Minute No. 63
Report – Standing Policy Committee on Property and Development, Heritage and Downtown Development – November 19, 2018

Item No. 6 **Subdivision and Rezoning – 1493 Magnus Avenue (Point Douglas Ward) File DASZ 9/2018 [c/r DAV 125313/2018D]**

Title: DASZ 9/2018 – 1493 Magnus Ave

Issue: An application for consideration at the Public Hearing to rezone an existing "R1-M" residential single-family zoning district to an "RMF-S" Residential Multi-Family (Small) zoning district, consolidate all underlying lots and construct a townhouse development.

Schedule "A" for File No. DASZ 9/2018, Lord Selkirk – West KIldonan Community Committee, dated May 8, 2018

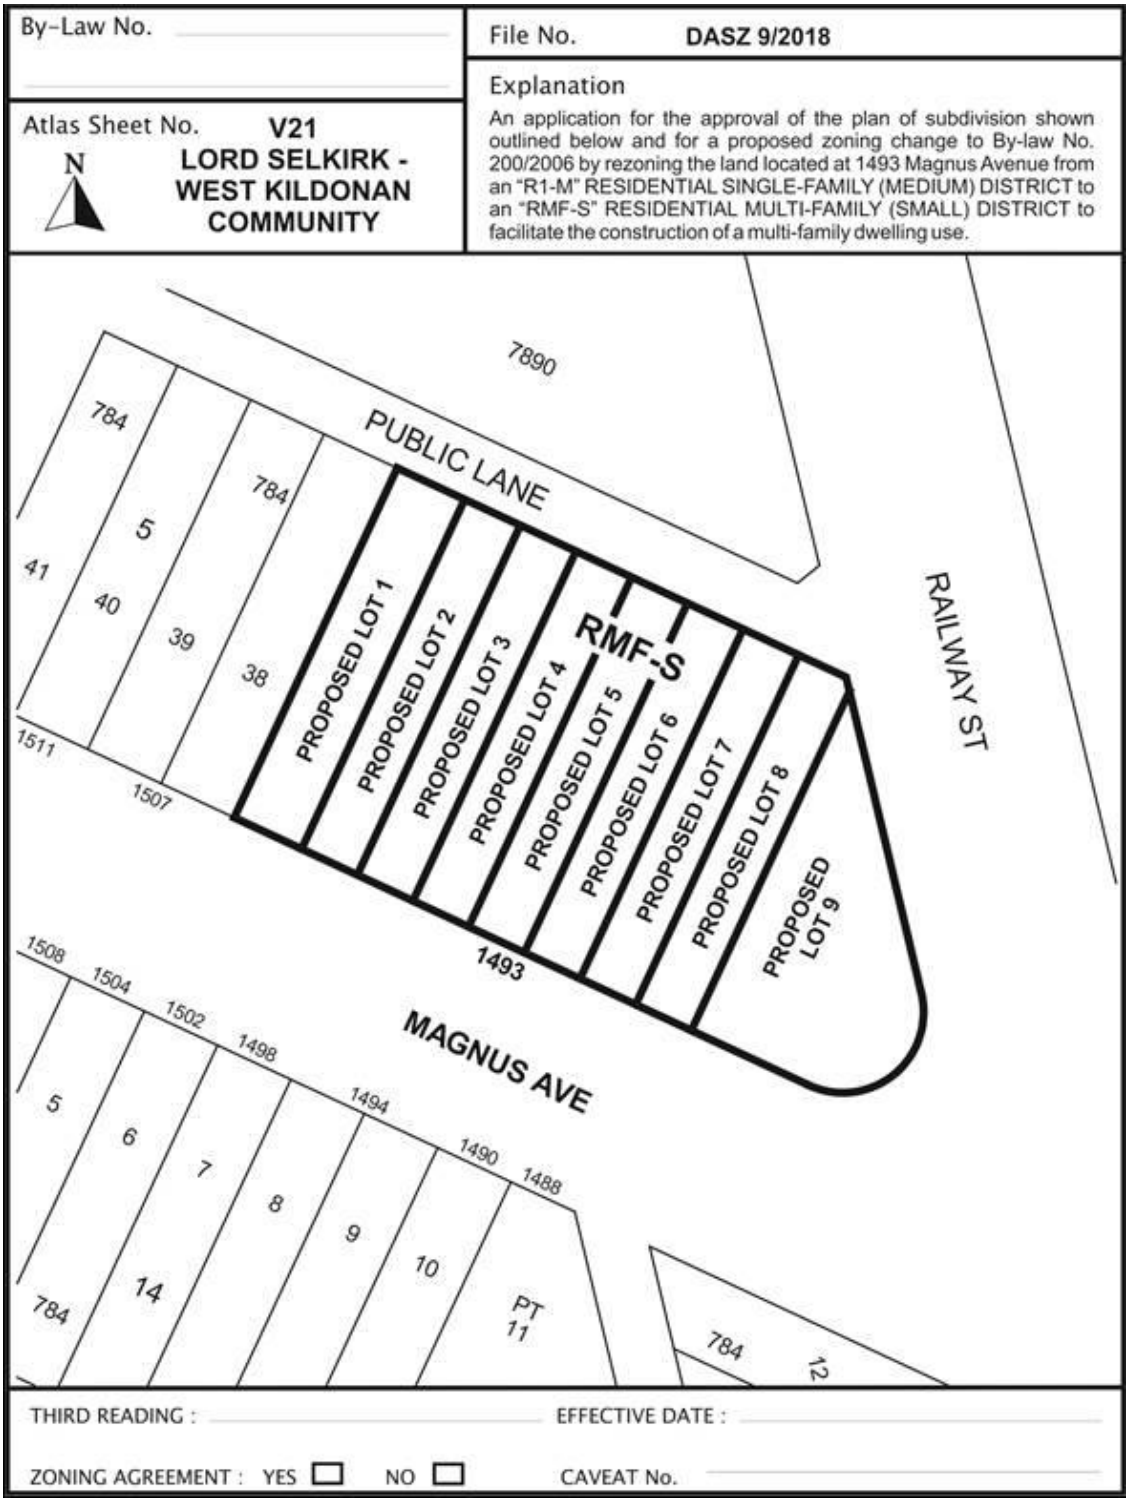
- *Reduced berm heights are possible where larger setbacks are proposed.*
- It is noted that the proponent’s site plan does not adhere to the above standards. The applicant is aware of the concerns of the Public Service and Council direction, but wishes not to construct the berm. Instead of rejecting the application altogether, the Urban Planning Division is recommending the above requirements be stated in recommended zoning agreement for this application.

- The Division believes the site plan can be modified in a number of ways to meet the *Federation of Canadian Municipalities “best practices”*. For example, if the proposed unit on Lot 8 remains in the same place under the recommended approval of Schedule ‘D’, the required berm on Proposed Lot 8 could easily be accommodated within the site due to the increased setback of the dwelling from the CPR Arborg Subdivision.

c) A minimum setback of 15 metres to any portion of a habitable room or space within a building located on the Developer's land, measured from the western property line of the CPR Arborg Subdivision.

Schedule "B" for File No. DASZ 9/2018, Lord Selkirk – West Kildonan Community Committee, dated August 20, 2018

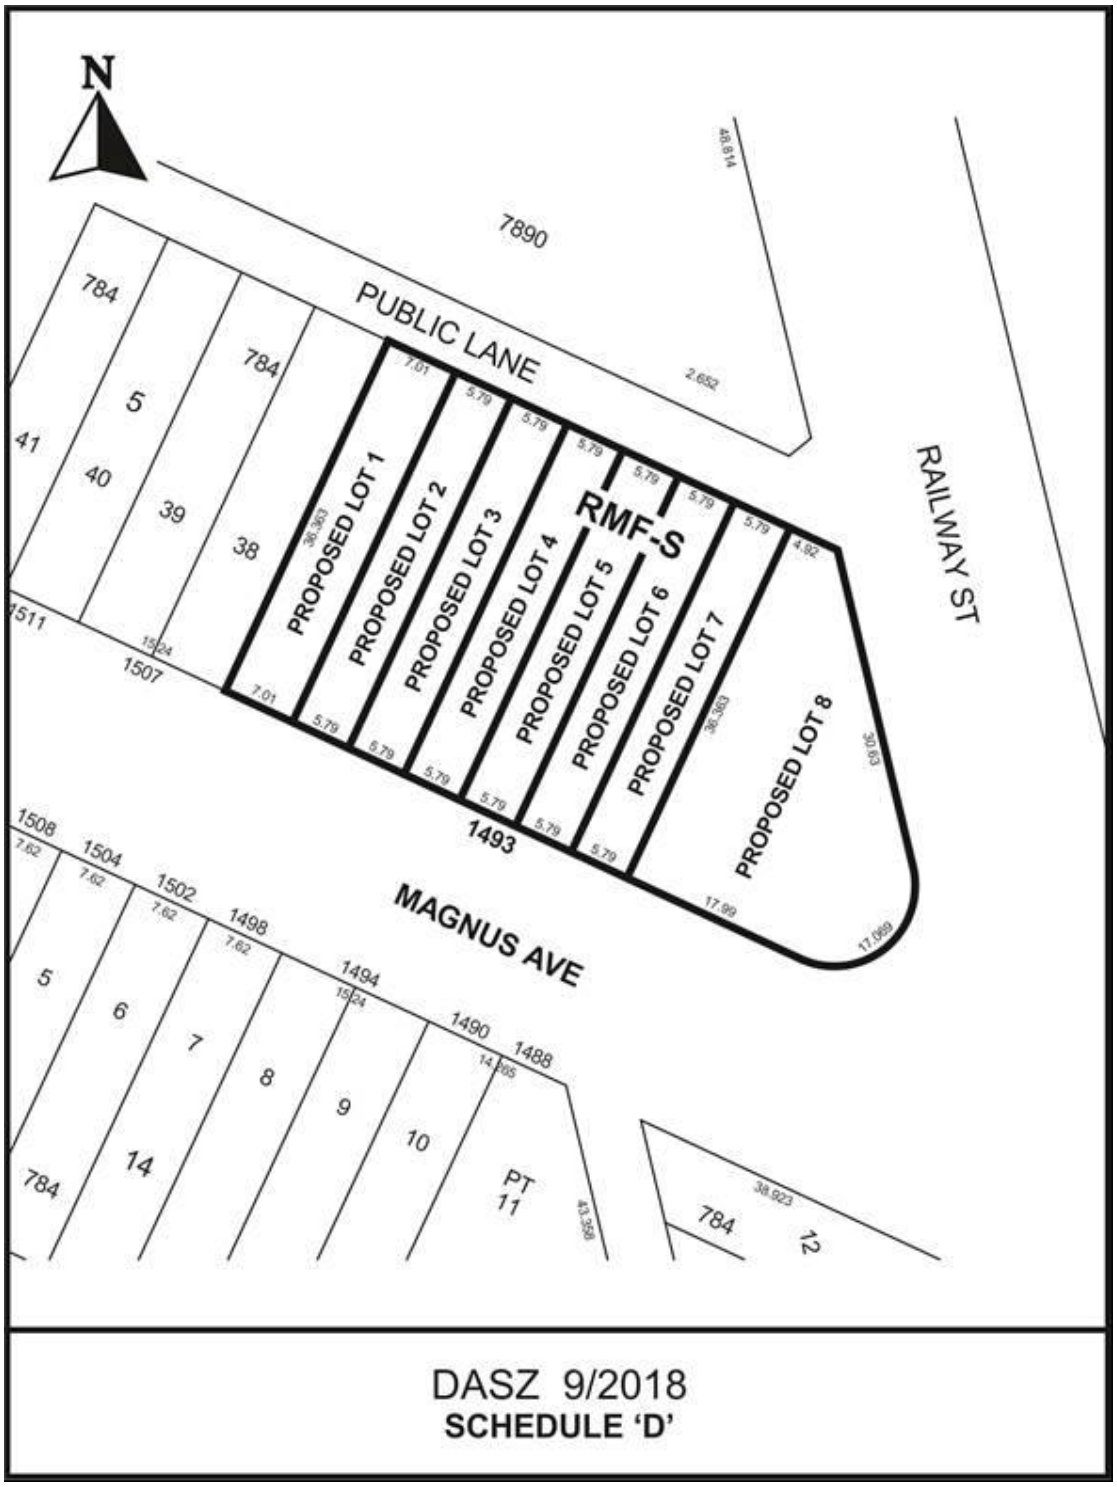
- However, there are aspects of the design of the proposed use that are inconsistent and incompatible with the existing character of the neighbourhood. Specifically, the site plan illustrates a private approach gaining access to proposed unit #9 from Magnus Ave. Given that the property is served by a public lane, the expectation is that all vehicular access to the site must be from the public lane. The Public Service believes there are alternatives to the design of the site to avoid the need for any approaches onto existing streets abutting the site. The length of the lane providing direct access to the subject site is approximately 150 feet which provides ample opportunity for site access.

- Given this situation, the Public Service recommends that proposed Lot 9 be amalgamated with Proposed Lot 8 to alleviate site access issues. To this end, a new Schedule (Schedule “D”) has been created and appended to this report and it is recommended it replace Schedule “A, the subdivision plan submitted by the applicant.

- As noted previously in this report, the proposed private approach on Magnus Ave is not supported. Therefore, while the Public Service recommends approval of the zoning designation to allow multi-family development, the applicant will be expected to revise the site plan to remove the approach and take access from the existing public lane.

i. There shall be no private approaches granted on Railway Street or Magnus Avenue
